PRDE20210046

For:  
**VECTOR DEVELOPMENT  
COMPANY**

Title:  
**FREEMAN ROAD LOGISTICS  
DEMOLITION PLAN**

Sheet  
**1 of 5**

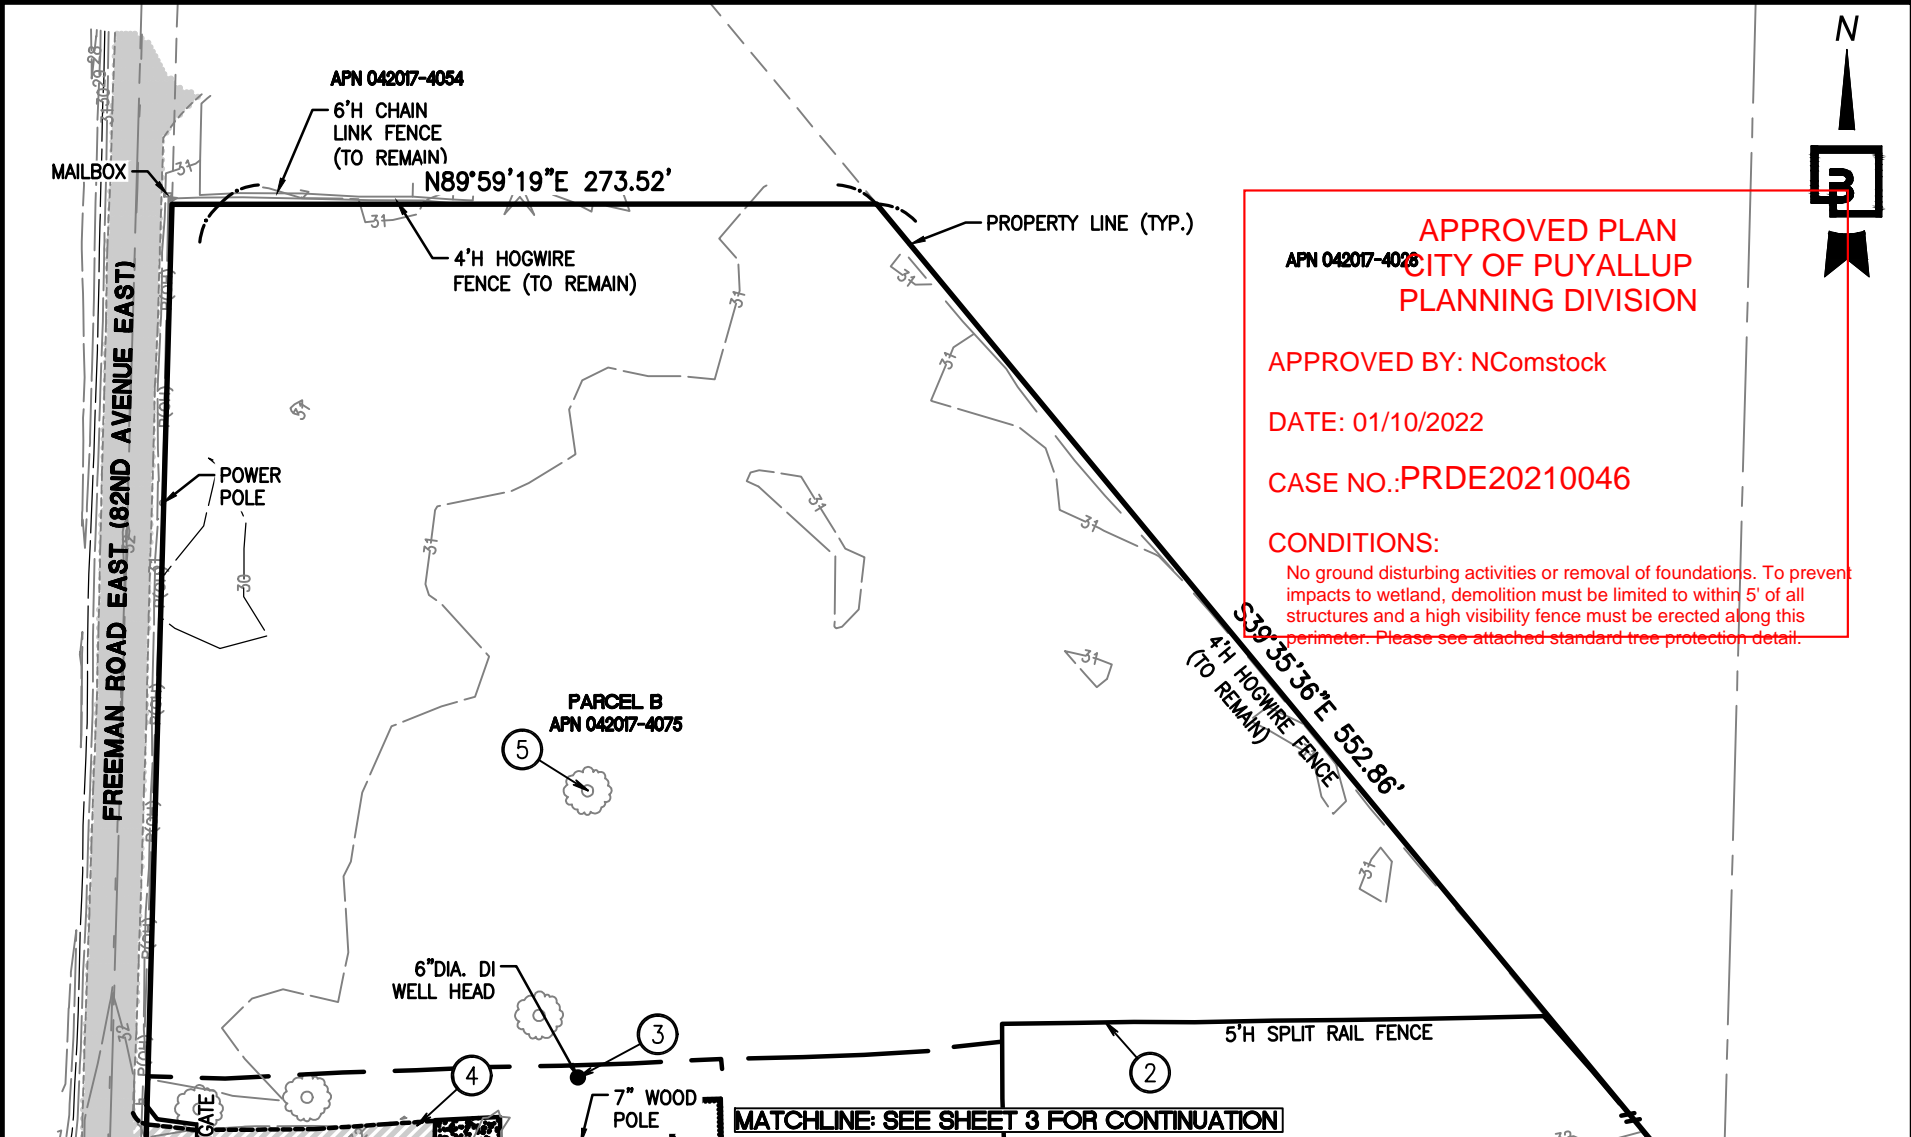
The applicant is responsible to demolish the existing septic system per Tacoma Pierce County Health Department standards. A septic decommissioning certificate is required to be filed with Pierce County and a copy submitted to the City of Puyallup.

The applicant shall demolish the existing private well per Tacoma Pierce County Health Department standards or install an approved reduced pressure backflow device on the City water service. A well decommissioning certificate shall be filed with Pierce County and a copy submitted to the City of Puyallup.

Refer to the City standard details 02.03.02 & 05.02.01 for typical erosion and sedimentation control methods.

Prior to starting site work, request an erosion and sediment inspection through the CityView portal.

Engineering approval required for utility disconnects prior to building inspection final. Final inspection required.

Sheet  
**2 of 5**

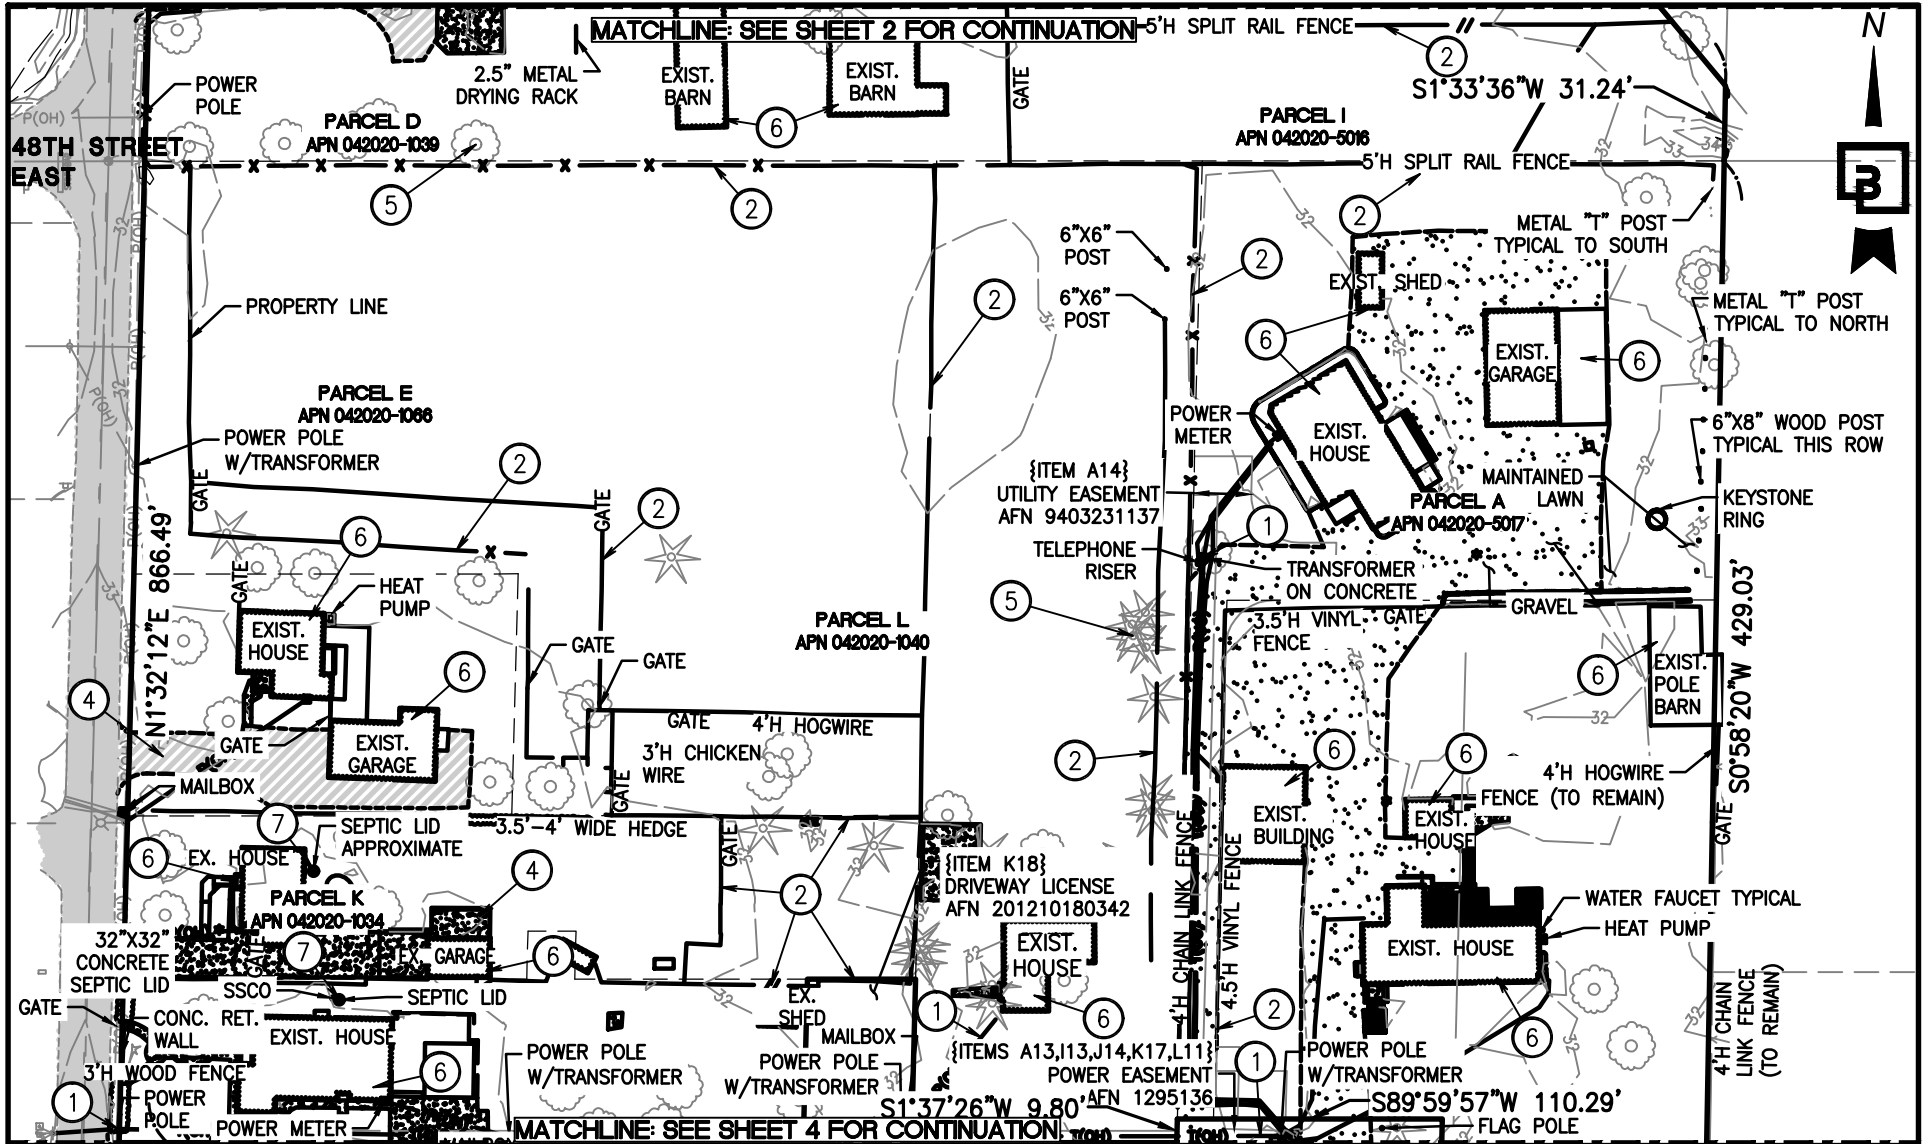
**CONDITIONS:**  
 No ground disturbing activities or removal of foundations. To prevent impacts to wetland, demolition must be limited to within 5' of all structures and a high visibility fence must be erected along this perimeter. Please see attached standard tree protection detail.
